15 June 2018

Our Reference: SYD17/01668/03
Council Ref: DA17/1092

**REVIEW OF SIDRA MODELLING AND TRAFFIC REPORT FOR CEMETARY &
CREMATORIUM
13-15 PARK ROAD, WALLACIA**

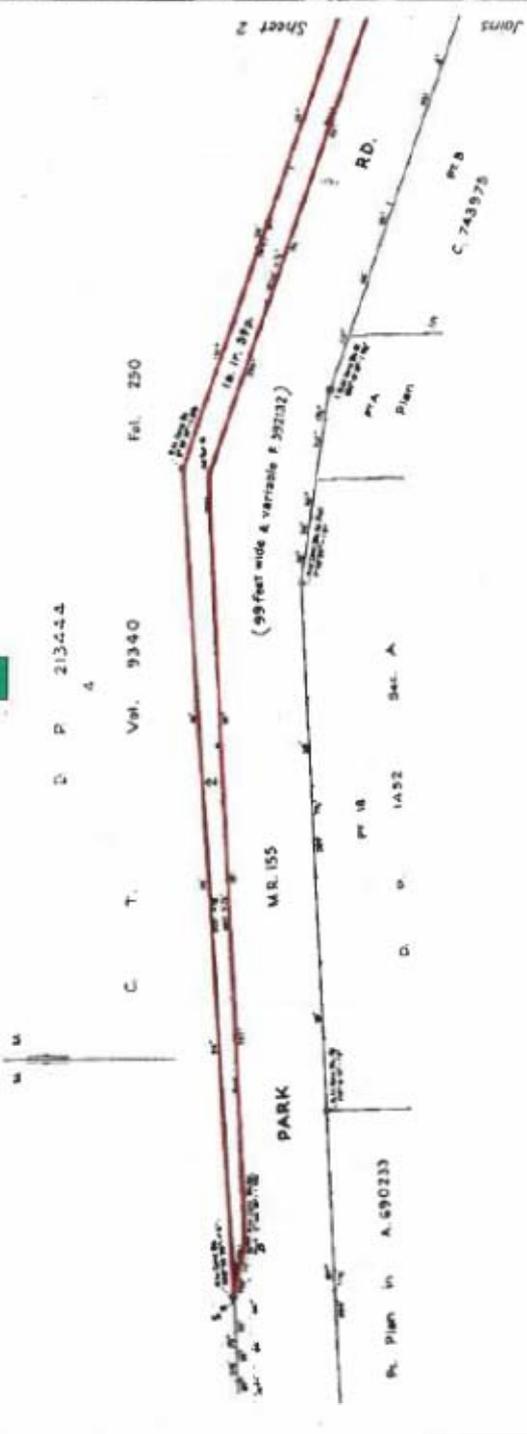
1. Roads and Maritime has previously acquired a strip of land for road along the Mulgoa Road frontage of the subject property, as shown by blue colour on the attached Aerial – "Z". Roads and Maritime has also previously resumed and dedicated a strip of land as road along the Park Road frontage of the subject property, as shown by grey colour on the attached Aerial – "X", "Y" and "Z". The subject property is further affected by a Road Widening Order under Section 25 of the Roads Act, 1993 as published in Government Gazette No. 112 of 20th October 1967; folio 3854, as shown by pink colour on the attached Aerial – "X" and "Y" and DP 227202. Therefore, any new buildings or structures, together with any improvements integral to the future use of the site are to be wholly within the property boundaries and erected clear of the land reserved for road widening (unlimited in height or depth). The area required for road should be identified on any plan of development.
